# Rear Roof Cap Rivets

# RECALL

**MODELS AFFECTED:** 2005 through 2009 model Blue Bird Vision and All American School Buses manufactured at Fort Valley, Georgia from January 22, 2004 through March 28, 2008 and 2004 through 2007 model Blue Bird Vision and All American School Buses manufactured at Lafayette, Georgia from March 06, 2003 through June 16, 2006.

R08NC

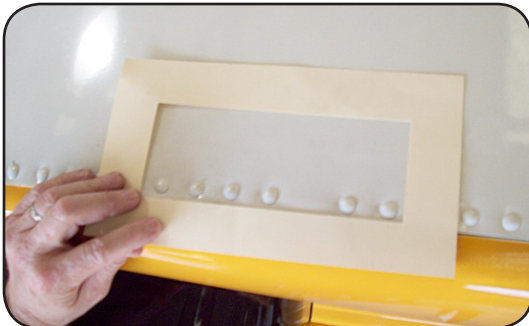
**2** Inspect rivet spacing at rear roof sheet and rear roof cap joint. Joint must have a minimum of six rivets in an eight inch segment.

2.1 Place the template over the joint and parallel to the edge of the roof sheet, allowing roof rivets to be exposed through the opening in the template as shown.

2.2 Move the template from one side of the rear roof cap to the opposite side.

2.3 If a segment in the rear roof cap joint contains less than six rivets, additional rivets are required. Mark each area that requires additional rivets.

2.4 If one rivet is required; add a rivet equally spaced between the two rivets with the largest space in this section.

2.5 If additional rivets are required; add additional rivets between the largest spaces until a minimum of six (6) rivets have been added in the eight (8) inch segment.

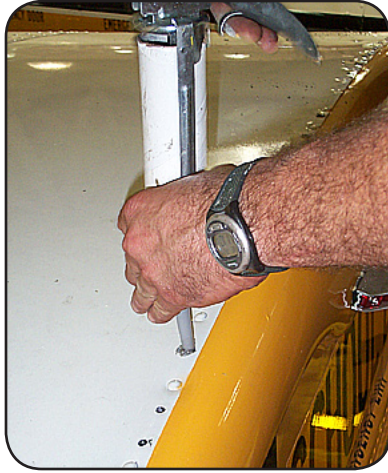
**3** Install rivet/s at each mark. Using a short 17/64" drill bit, drill a hole through the roof cap, roof sheet, and rear bow flange. Be sure to drill hole on a common centerline with existing rivets.

**4** Place a small amount of Vinyl Gray 5522 Sealant (Blue Bird # 0898627) in each drilled hole.

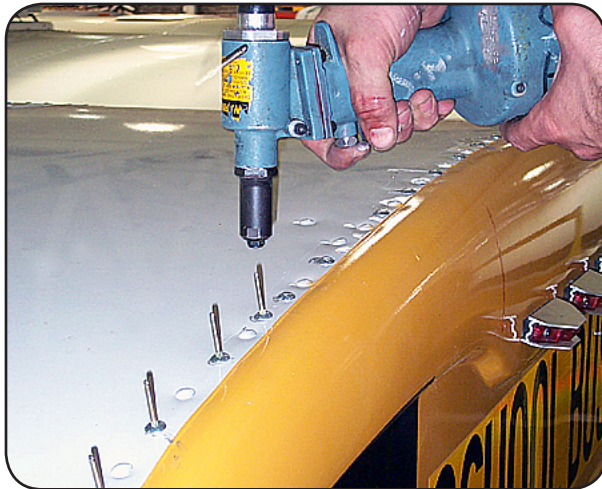
**5** The supplied 1/4" blind rivets (Blue Bird # 1854397) are pre-painted white or school bus chrome yellow. Install a rivet of the appropriate color into each hole.

**6** Clean up any sealant that may have squeezed out or smeared during rivet installation.

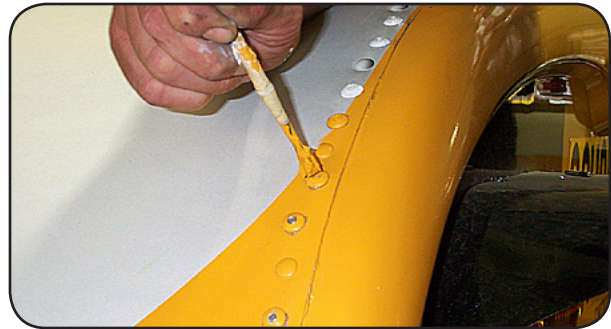
**7** With the correct color paint, touch up the center of each blind rivet where the stem was removed during installation.
